6.3.01 Accommodation Changes/ New Dwelling Types

6.3.02 Consented Dwelling Types Amendments

6.3.03 External Envelope Amendments (arising from internal layout changes)

07 | The Public Realm

Type T216 (Levels 1-9) As Consented

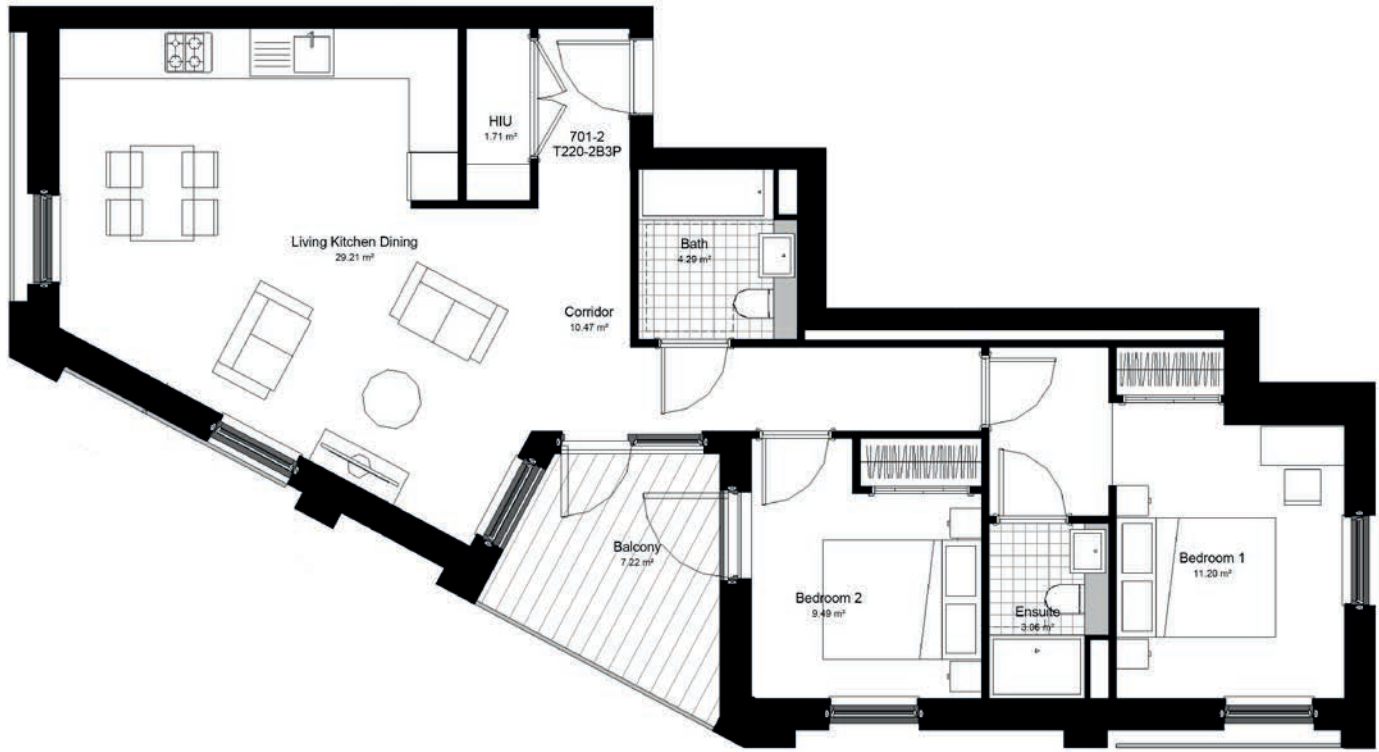
6.3.02 Consented Dwelling Types Amendments

Type T216 (Levels 1-9) Suggested Layout

Type T411 (Level 10) As Consented

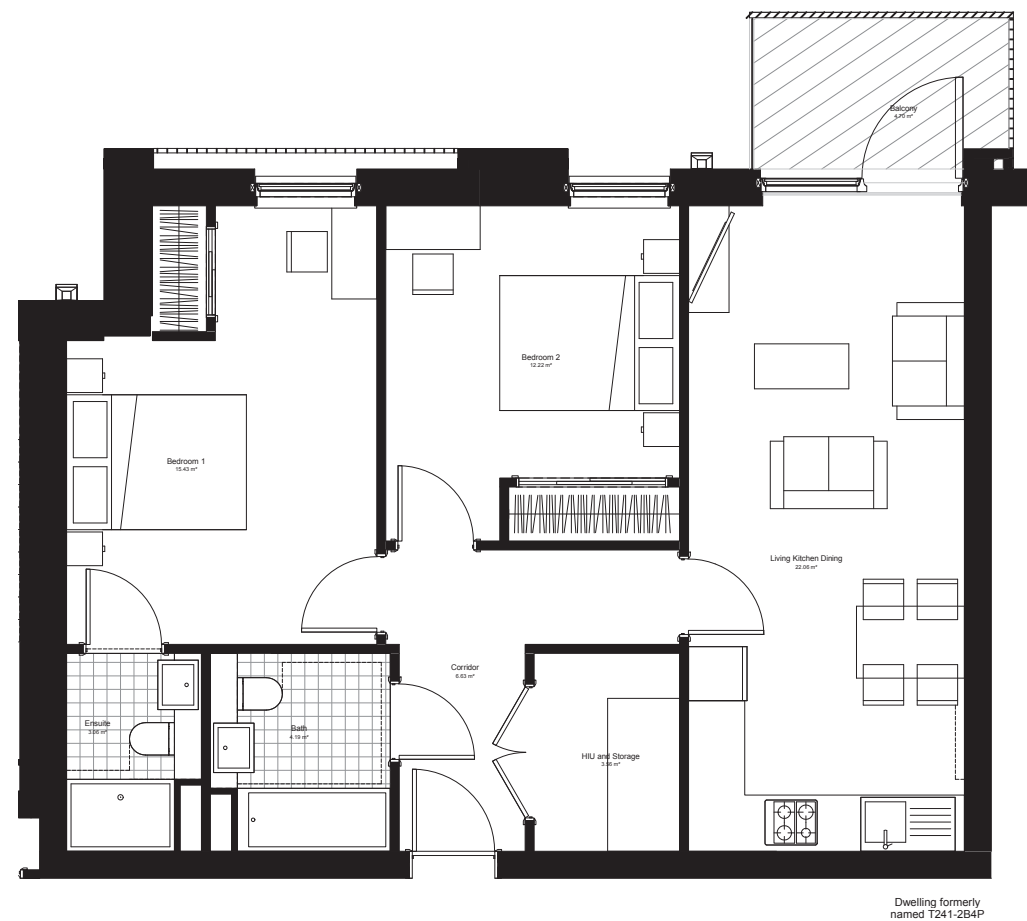
6.3.02 Consented Dwelling Types Amendments

Type T411 (Level 10) Suggested Layout

Type T241 (Levels 1-6) As Consented

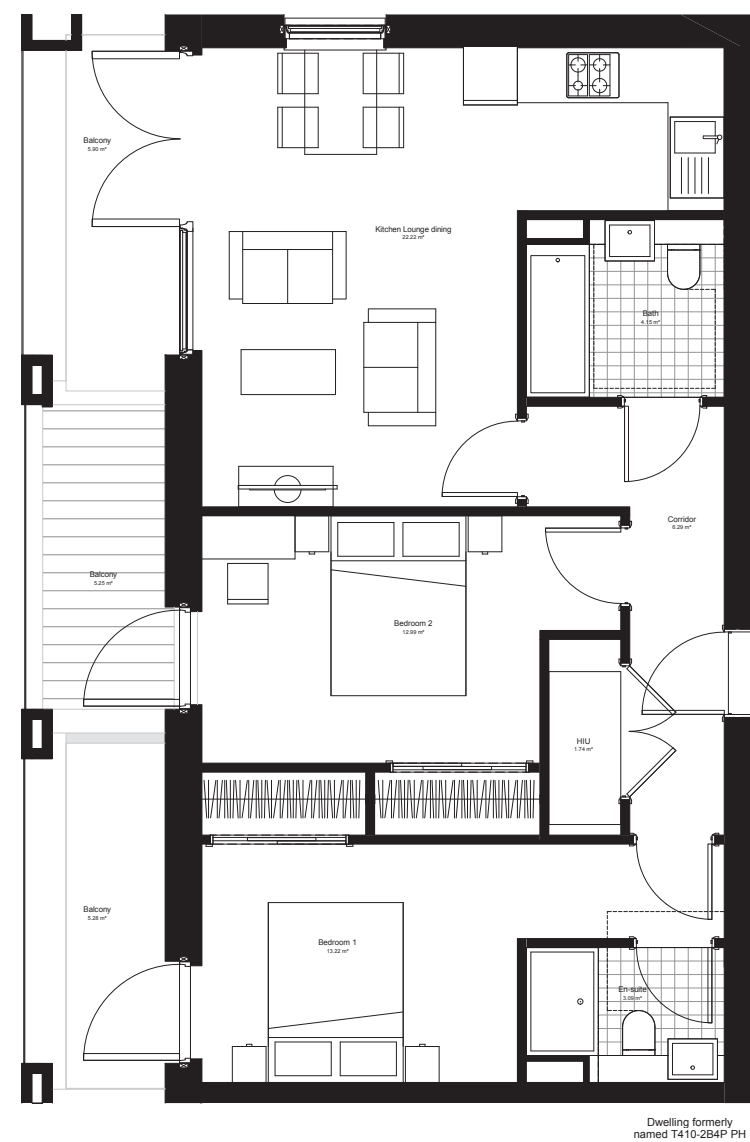
6.3.02 Consented Dwelling Types Amendments

Type T241 (Levels 1-6) Suggested Layout

Type T410 (Level 10) As Consented

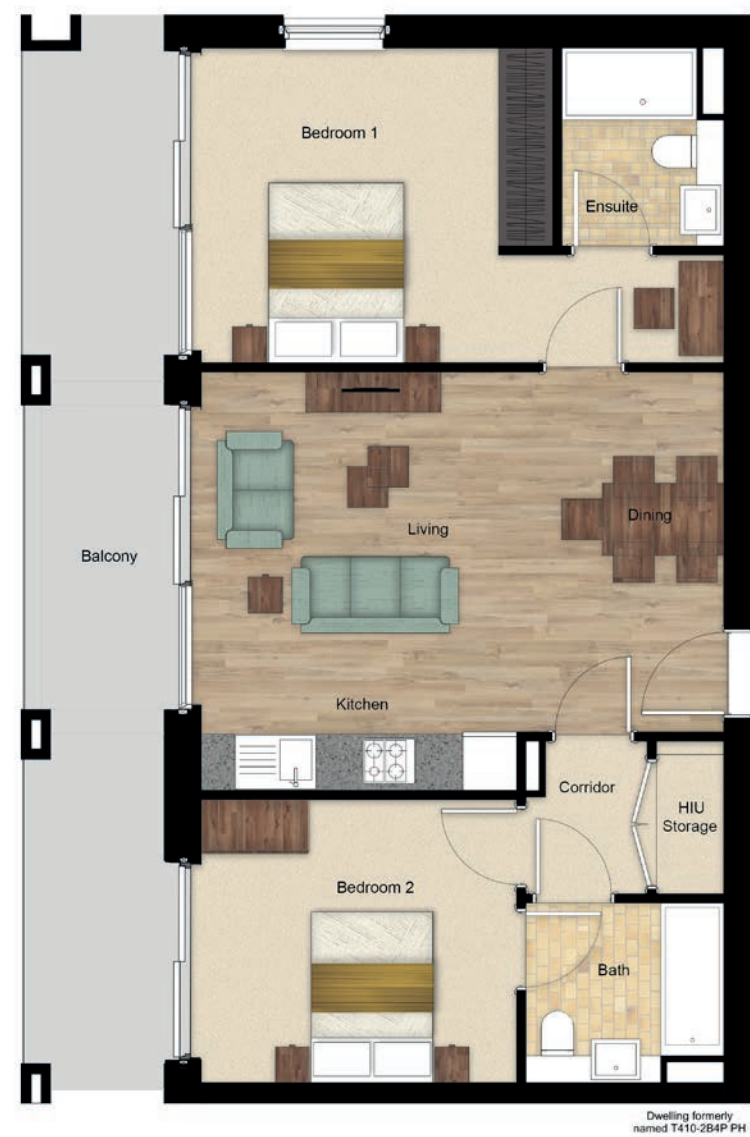
6.3.02 Consented Dwelling Types Amendments

Type T410 (Level 10) Suggested Layout

Layout Changes with Elevational Impacts
Isometric View from North

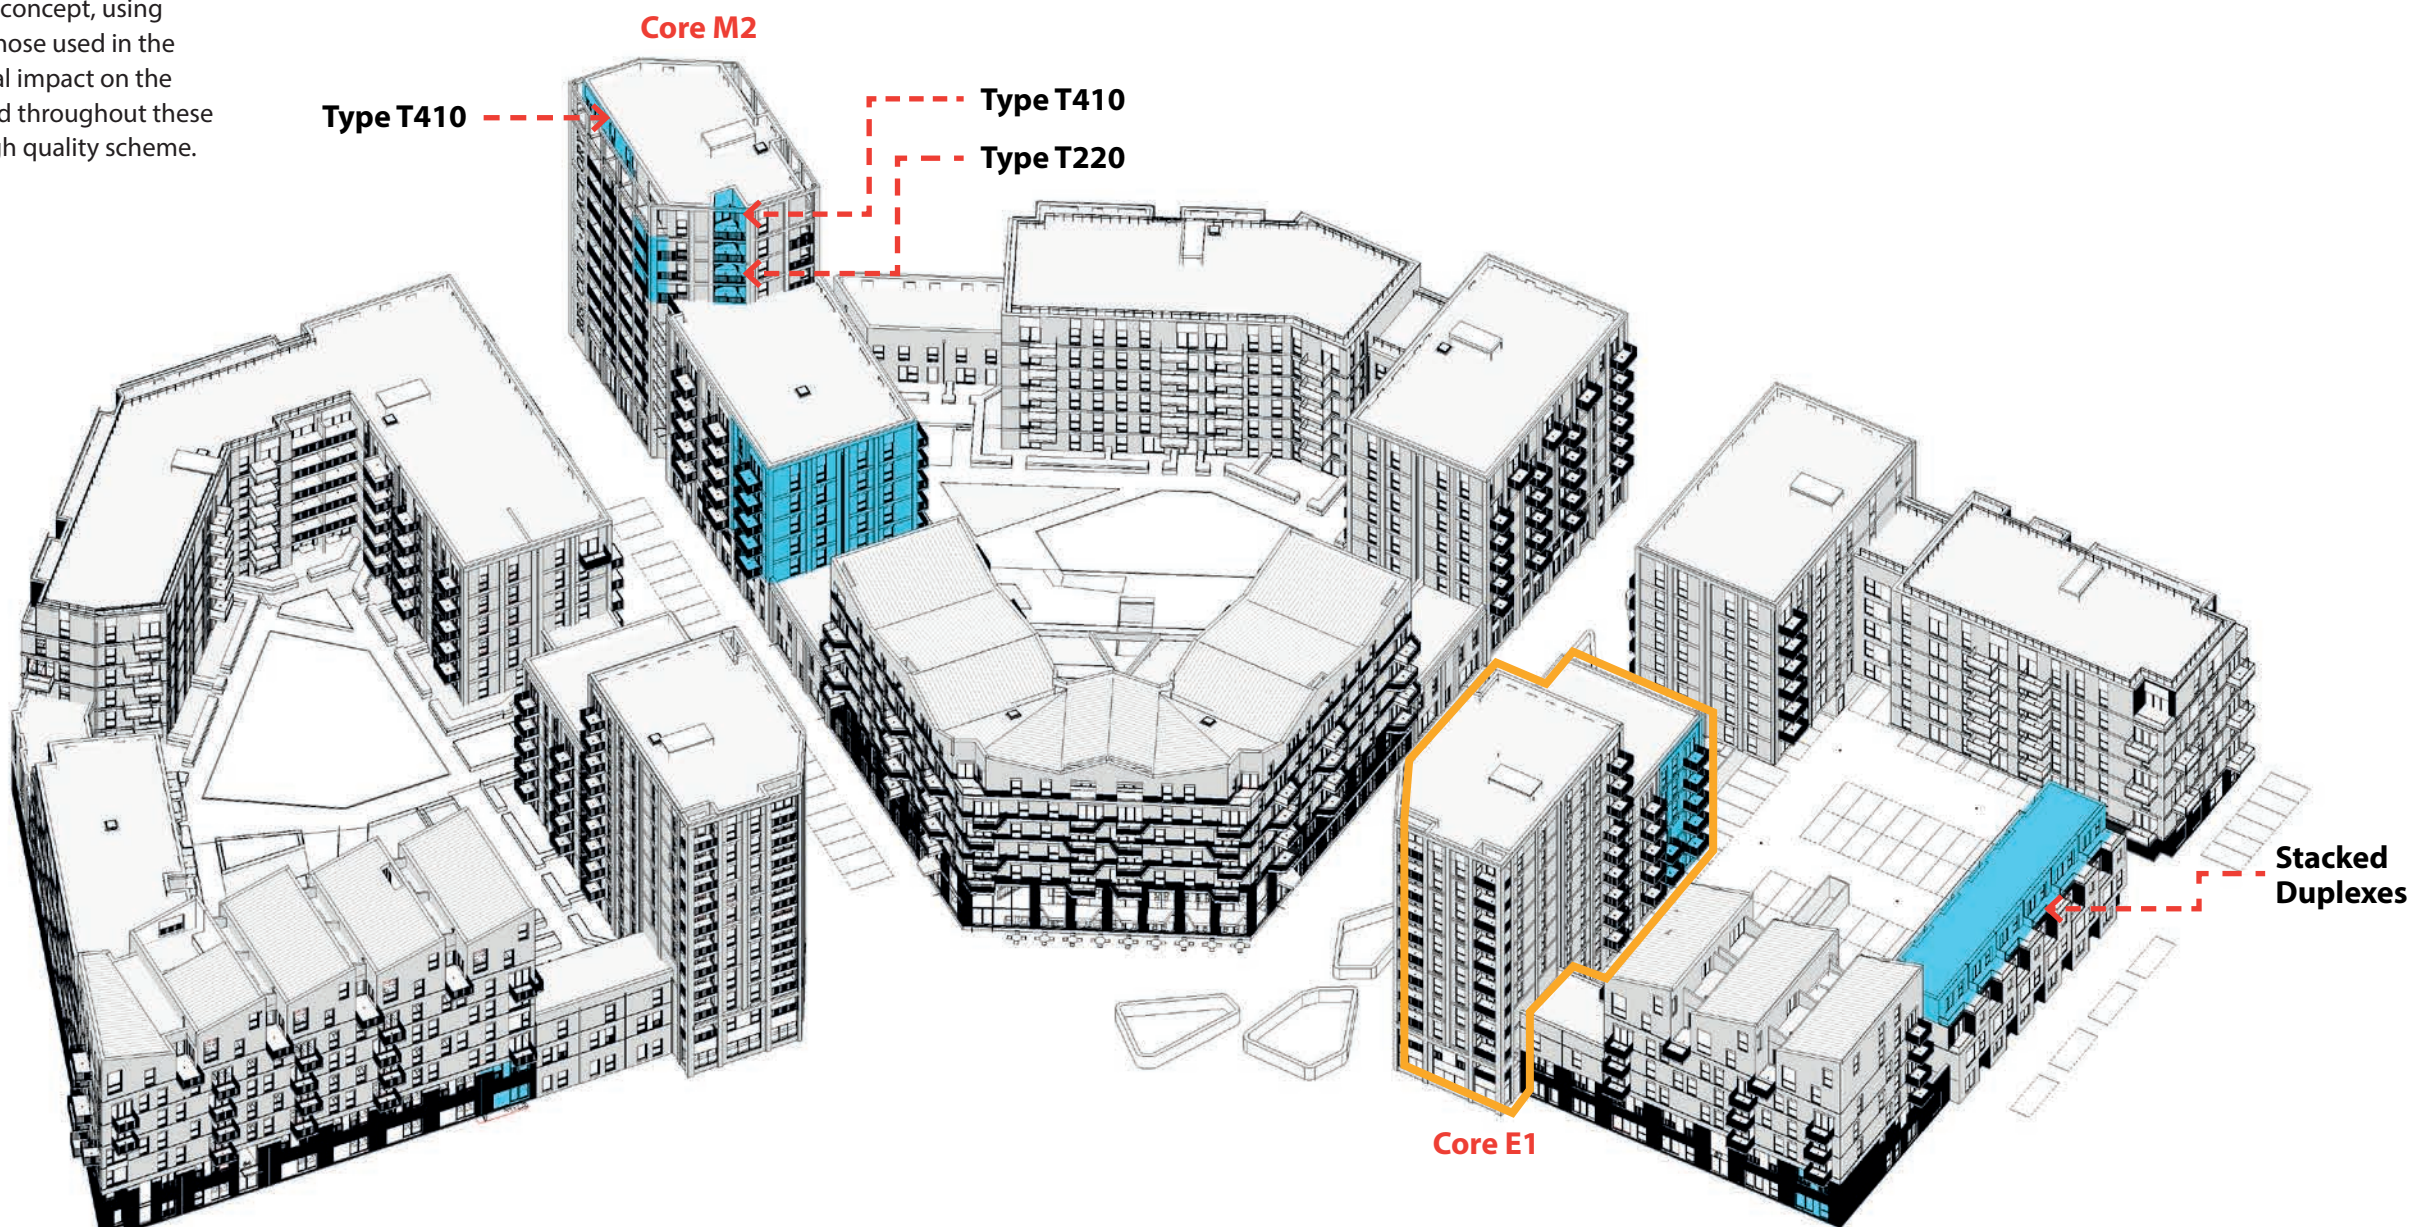
The development of the scheme follows the design intent presented in the consented Design and Access Statement. As a result of internal layout changes, amendments to the elevations have been incorporated. Any changes to these elevations have been considered against the overall design concept, using materials and details which closely match those used in the consented scheme. This is to ensure minimal impact on the facades. Design aspirations were maintained throughout these amendments to ensure the delivery of a high quality scheme.

Layout Changes with Elevational Impacts
Isometric View from North

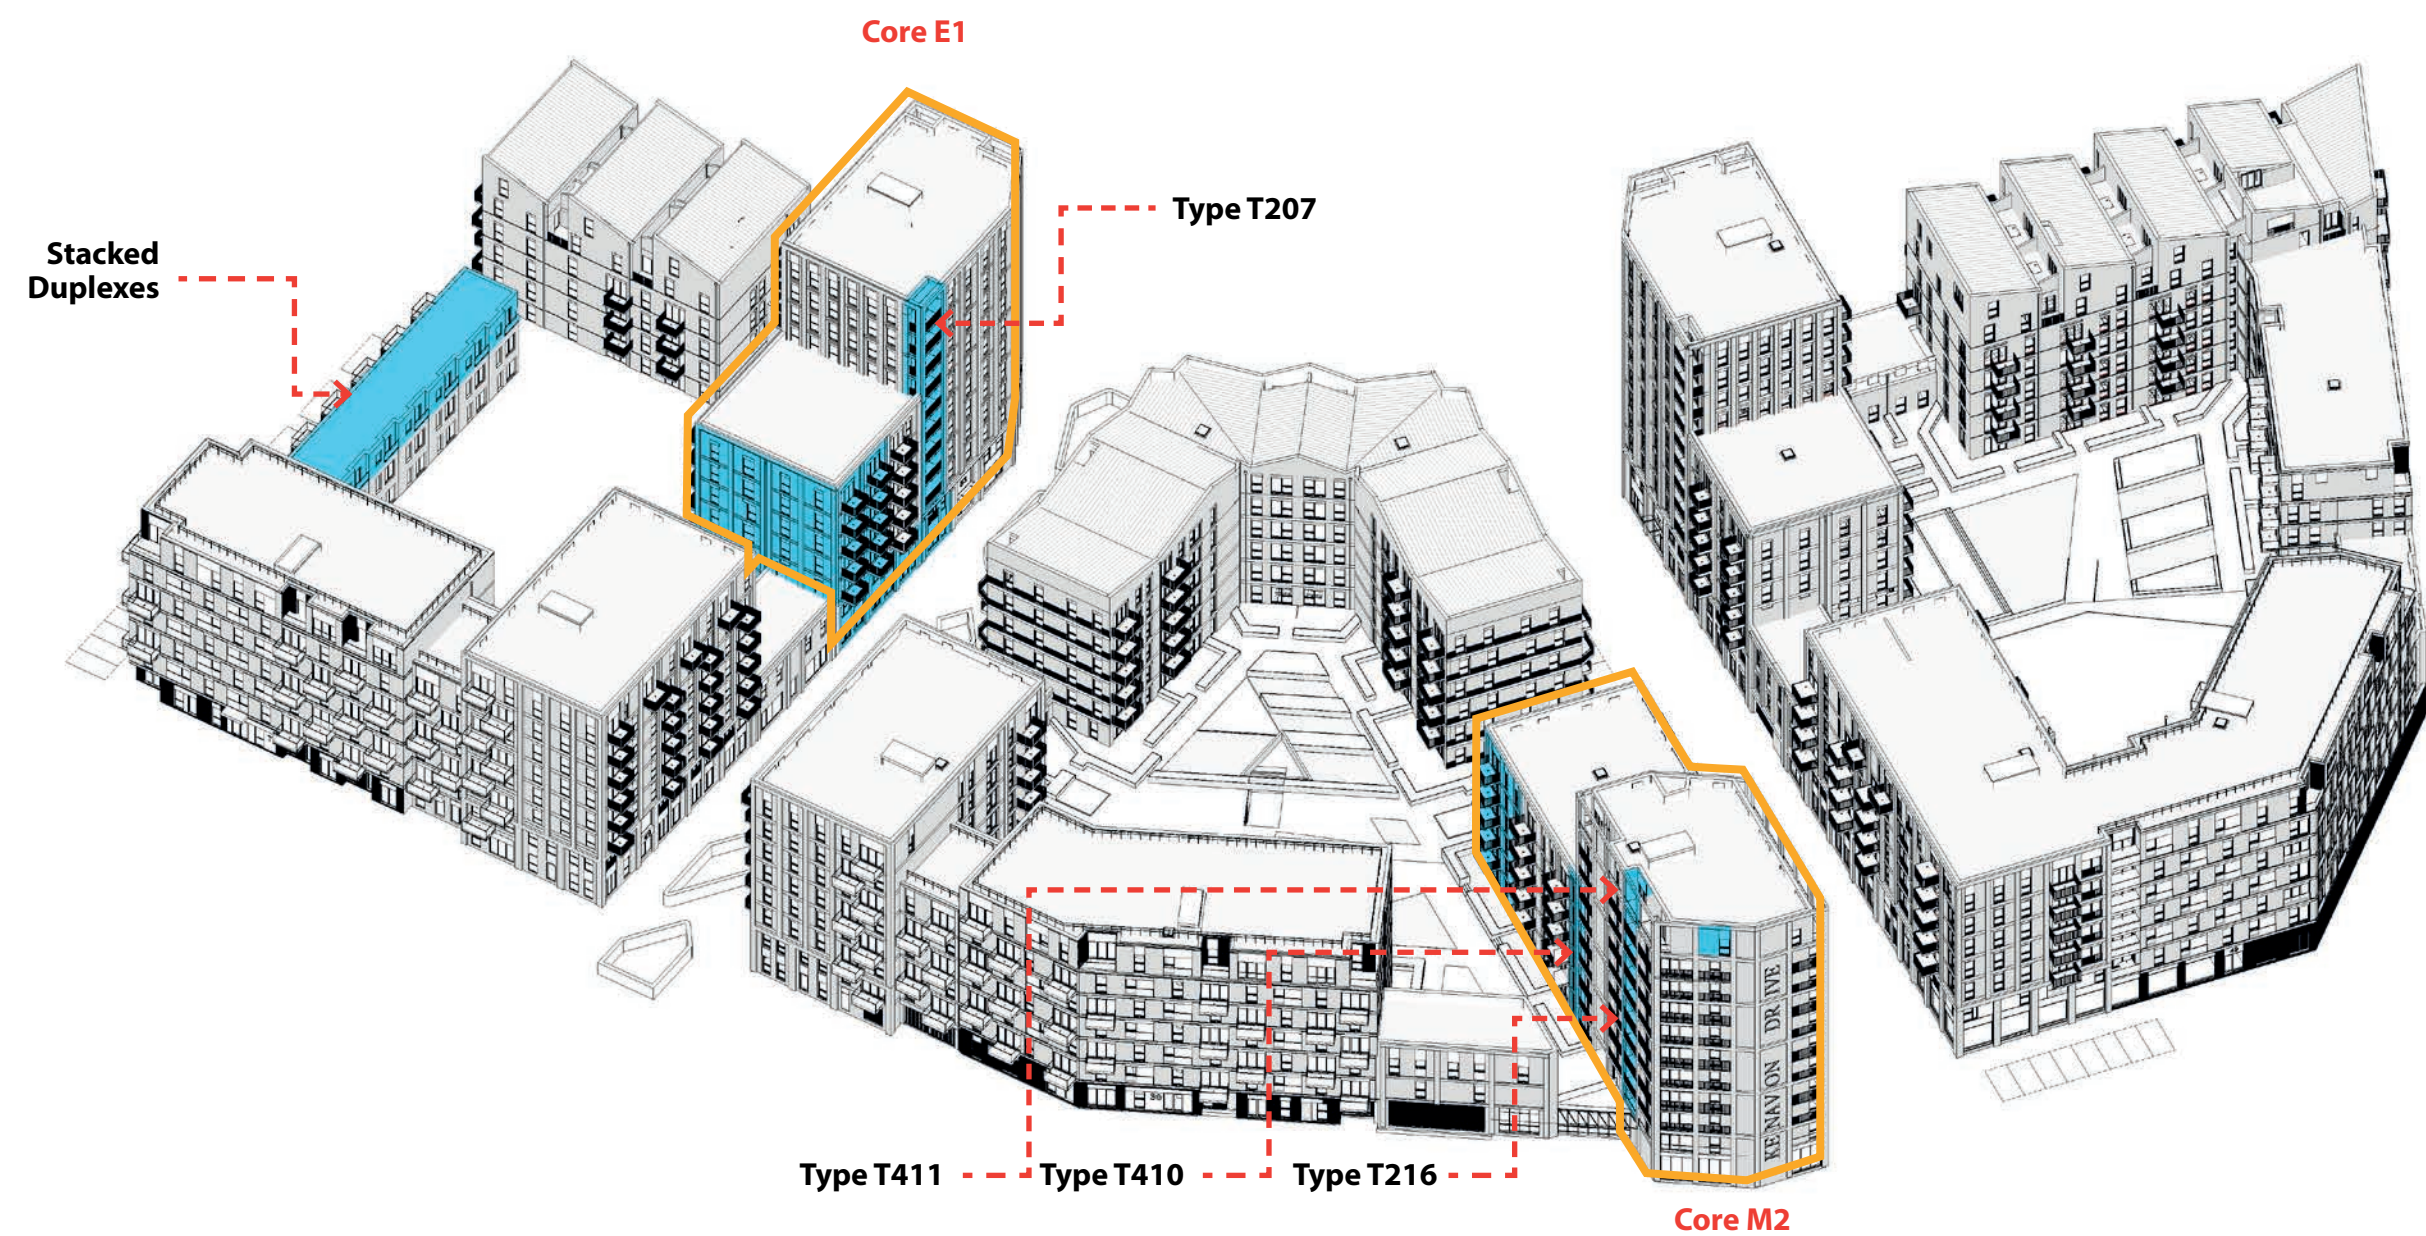
6.3.03 External Envelope Amendments (arising from internal layout changes)
